Access Compliance Report

Public Rights-of-Way

(Curb Ramps)

Intersection ID: 28523	Main Street: LEAZER_CT	Cross Street: GUNNISON_LN	Location: NW
ADA ID: 340A85DC1582	Ramp Type: PerpDiag	Initial Pass/Fail: Fail	Overall Compliance: No
		Severity Score: 12.5

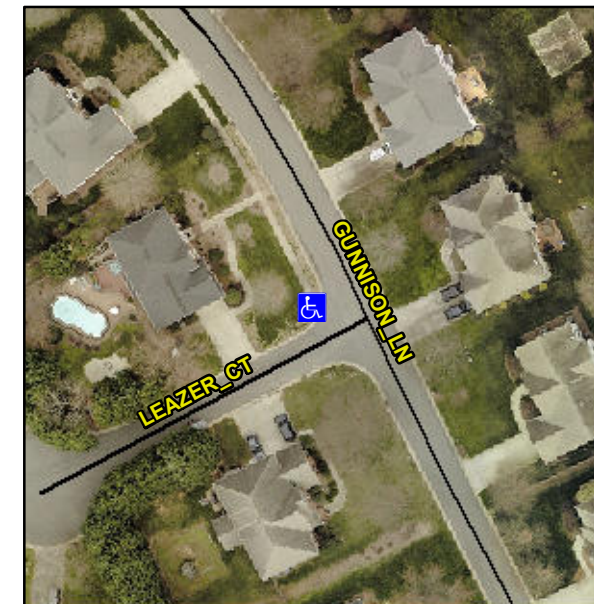
R304.2.2

Compliance	Description	Data	Compliance	Description	Data
N/A	Ramp Length (in)	54.0	No	Ramp Slope (%)	9.0
Yes	Ramp Width (in)	48.0	Yes	Ramp XSlope (%)	1.9
N/A	Flare Type LT	N/A	N/A	Flare Type RT	N/A
N/A	Flare Slope LT (%)	N/A	N/A	Flare Slope RT (%)	N/A
N/A	Flare Traversable LT?	N/A	N/A	Flare Traversable RT?	N/A
N/A	Landing Length (in)	N/A	N/A	DWS Provided?	N/A
N/A	Landing Width (in)	N/A	N/A	DWS Contrast?	N/A
N/A	Landing Slope (%)	N/A	N/A	DWS Length (in)	N/A
N/A	Landing X Slope (%)	N/A	N/A	DWS Full Width?	N/A
N/A	Landing Curb? (Y/N)	N/A	N/A	DWS Offset (in)	N/A
N/A	Shared Landing?	N/A			
N/A	Gutter Ponding?	N/A	N/A	Gutter Slope (%)	N/A
N/A	Gutter Lip Ht (in)	N/A	N/A	Gutter X Slope (%)	N/A
N/A	Painted X Walk1?	No	N/A	Painted X Walk2?	No
	X Walk 1 Direction	To SE		X Walk 2 Direction	To NE
N/A	X Walk 1 Width (in)	N/A	N/A	X Walk 2 Width (in)	N/A
	X Walk 1 Slope (%)	6.5		X Walk 2 Slope (%)	3.3
	X Walk 1 X Slope (%)	3.2		X Walk 2 X Slope (%)	4.7

Remove & Replace Curb Ramp With Two New Directional Ramps or Equivalent.
